## PRODUCT CHANGE NOTIFICATION

Product Identification: Bel 0862, 0867, 08B2 & 08C2 USB Combo ICMs

PCN Number: PC2180124

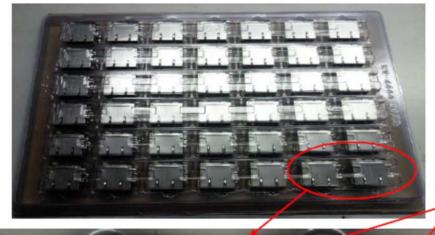
Description of the Change (s): Bel is updating the design of the top packaging tray by adding a simple indentation to fix the part between the 2 trays while not disturbing the connector leads.

Old top tray: the holder of the top tray is close to the shield pins and will have a chance to have the shield pin deformed by pressure.

New top tray: modify the holder design in the tray to avoid touch the shield pins properly. It will be helpful to improve the potential defect and have a better protection for the product.
